**TOWN OF BROOKLYN  
PLANNING AND ZONING COMMISSION  
Agenda  
Wednesday, March 6, 2024, 6:30 p.m.**

## **ENGINEERING PLAN AND DRAINAGE REPORT REVIEW**

The comments contained herein pertain to my review of plans (9 sheets) for the construction of a seven (7) lot conservation type of residential subdivision with private road. The plans were prepared by Archer Surveying, LLC, dated October 27, 2023 (revised January 15, 2024), for Tetreault Building Company.

#### **Cover Sheet – Sheet 1 of 9**

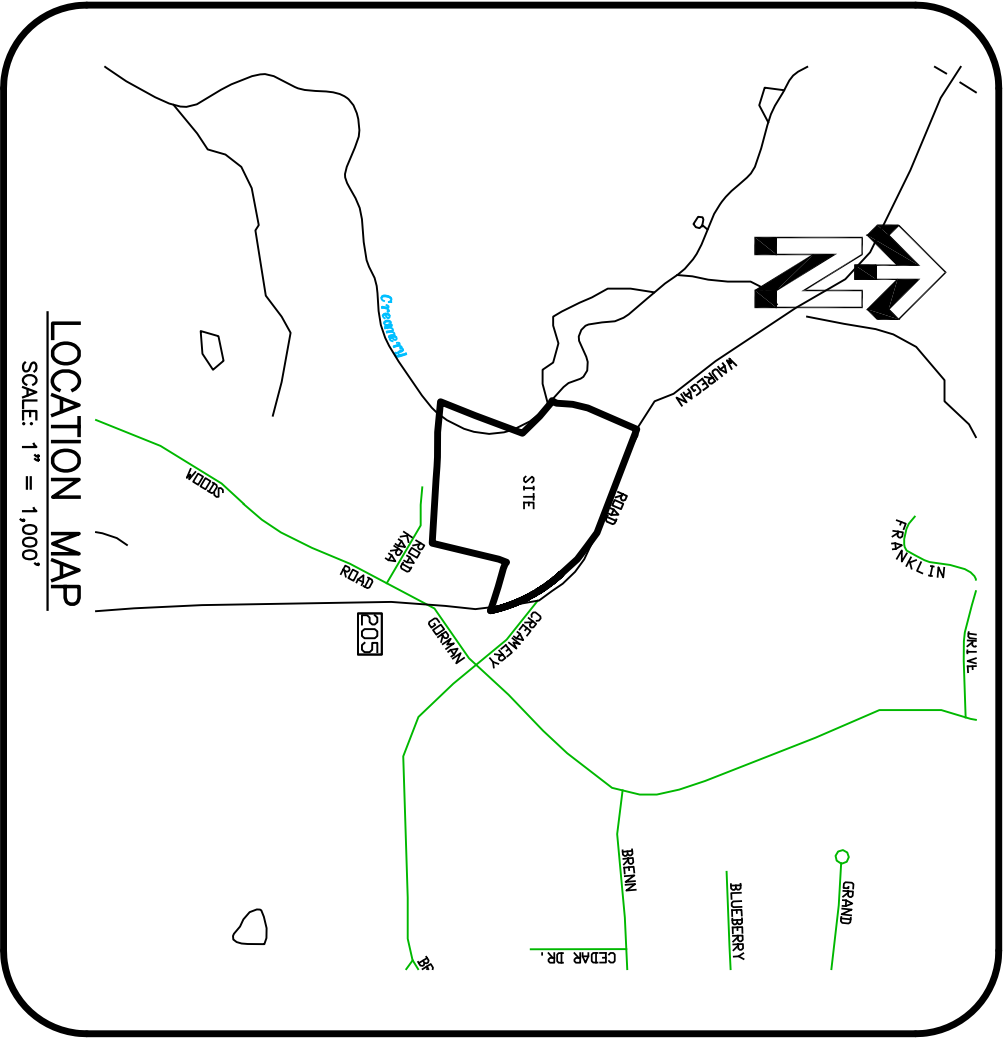
1. The revision date of December 28, 2023 is incorrect. The plans have been revised as recently as January 15, 2024. If the intent is to show all revision dates on the Cover Sheet, the following revision dates will need to be added:

2. Since this is a conservation type subdivision, add the word “Conservation” to the title of the plan set. **DONE**
3. The Archer Surveying, LLC logo should be the same as displayed on Sheets 2 thru 9 of 9. **DONE**

January 25, 2024 & February 19, 2024 added
